In the Matter of
PACIFIC GAS AND ELECTRIC COMPANY
(Diablo Canyon Nuclear Power Plant, Units 1 and 2)
Docket Nos. 50-275 OL and 50-323 OL

PGandE Letter No.: DCL-84-141

Re: Docket No. 50-275, OL-DPR-76
Diablo Canyon Unit 1
SSER 22, Allegation No. 92/93 -- Pipe Support Tube Steel

ENCLOSURE

Fig. A

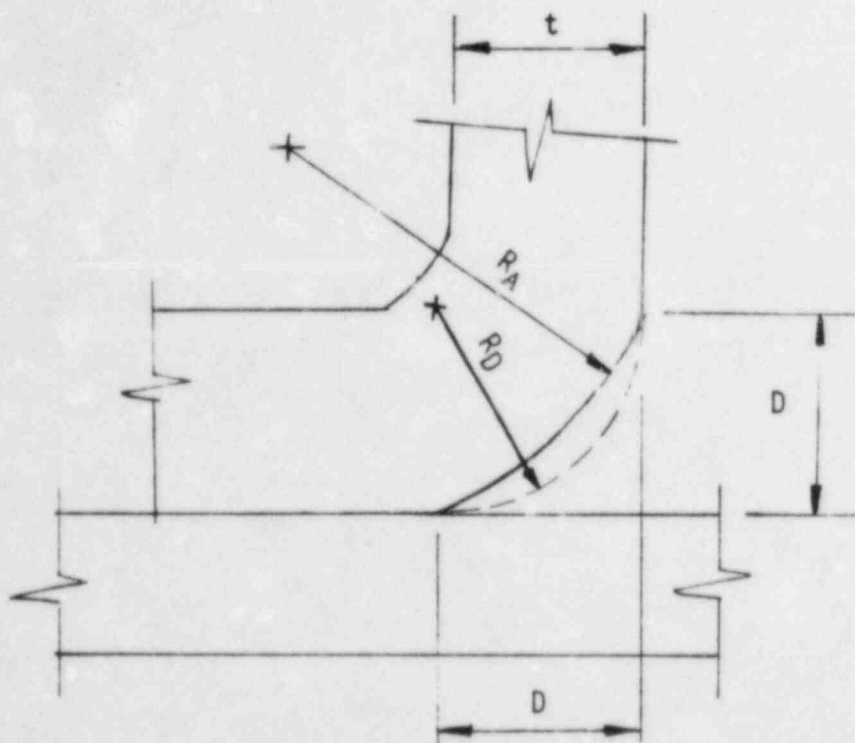
The curved portion of the tube corner is not fabricated to be exactly one quarter of a circle, as indicated by the dotted line in Figure A. Instead, it is actually less than a quarter of a circle as indicated by the solid line in the same figure. Therefore, different radii can be measured for the tube corner dependent upon the measurement method used.

2. Explain the apparent discrepancy between the Staff's observations (corner radius = 1.5 t) and the statement in PGandE's February 29, 1984 letter relating to the fact that tube steel at Diablo Canyon had an outside corner radii of 2.0 t or greater.

The NRC Staff and Pullman QC have reported corner dimensions, as measured by the tangent intersection method, rather than measured by a curvature gauge. As discussed above and as shown in the attached figures, these measurement techniques lead to different conclusions. Although measurement of corner radii had never been an inspection requirement, a few jobsite measurements had confirmed the radius was 2.0 t or greater. The recent measurements made using a curvature gauge and the weld testing that measured the effective throats of the associated flare bevel welds reconfirmed the validity of the 2.0 t or greater radius.

Fig. B

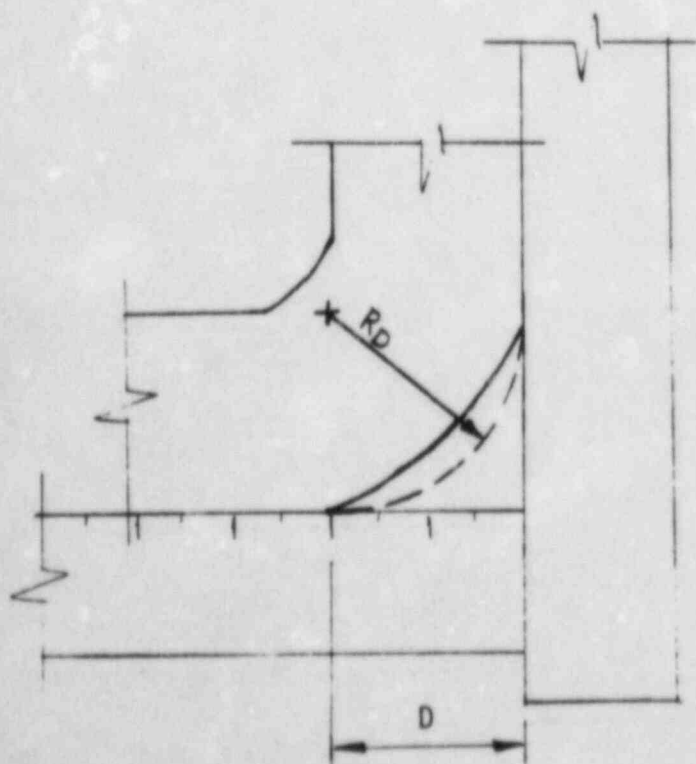
If a straight ruler or mechanic's square is used, as shown in Figure B, a corner dimension, D , is measured. This is considered to be the tangent intersection method. Based on this D dimension, an apparent corner radius of R_D is implied. As shown in Figure B, this may not be the actual radius of curvature. Alternatively, if a concave radius gauge is used, the measured radius is R_A , as shown in Figure C. R_A is the appropriate measurement of the actual curvature. Only when the tube corner is a quarter circle will the two measurement methods yield the same radius. Examples of tubes with the smallest corner dimension, D , were selected by the site piping contractor's QC personnel (Pullman QC) for further measurement. The resulting measurements are summarized in Tables 1A and 1B. The difference between R_D and R_A is clearly shown in these tables. For the $3 \times 3 \times 1/4$ tubes, the apparent radius, R_D , is approximately $1.25 t$ to $1.5 t$ and the R_A is always $2.0 t$ or slightly larger. For the $3 \times 3 \times 1/2$ tubes, R_D is approximately $1.0 t$ and R_A is again $2.0 t$. The NRC staff's contractor used the tangent intersection method of measurement.
